## Product Advisory

## PA 672

Models Affected: C4000 and C5000

SUBJECT: Winch line slack

**Planetary rotation drive and turntable worm drive winch**

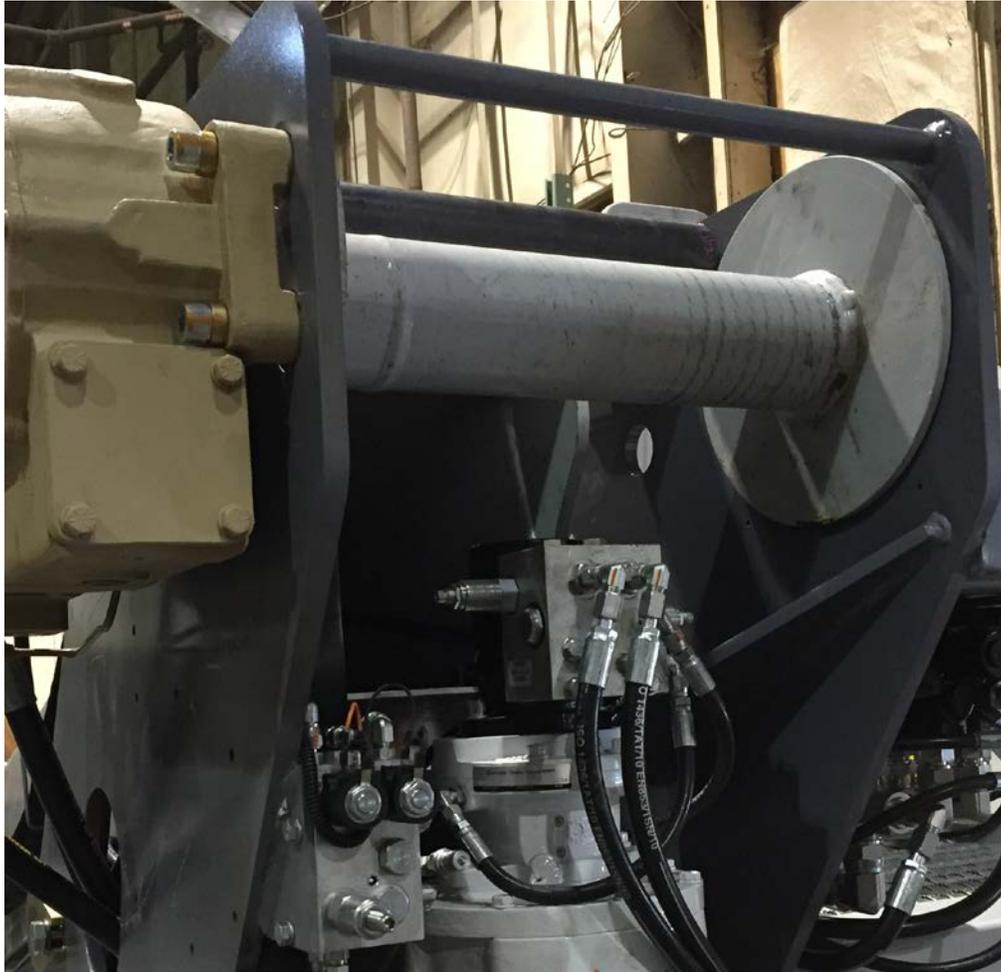
This bulletin applies to C4000 and C5000 models equipped with both a worm gear style turntable winch and planetary drive rotation. This combination may experience the winch rope snagging on valves below the winch drum if excessive slack is allowed to form in the line. Raising the boom or retracting the booms can allow slack to form if there is no load or insufficient weight on the end of the winch line. Digger derricks with planetary drive rotation built from Oct. 22<sup>nd</sup>, 2015 to Dec. 31<sup>st</sup>, 2018 have a valve block directly below the winch drum. **If Excessive slack in the winch line catches on the valves either the winch line or the valve cartridges may be damaged.**

Terex recommends that if you do not use a headache ball or swivel hook weight on the end of the winch line to maintain tension, slack can develop, a shield can be added to prevent the line catching on the valves below the winch drum. See pictures below for example

Terex will provide a shield field service kit P/N Z1500 to install below the winch drum. Terex will provide the parts and instructions at no charge for a period of one year from the release date of this bulletin. Installation labor is not compensated.

Installation of the shield will require drilling and tapping 4 holes to bolt the shield below the winch drum. The shield must be removable to service the rotation gearbox and motor.
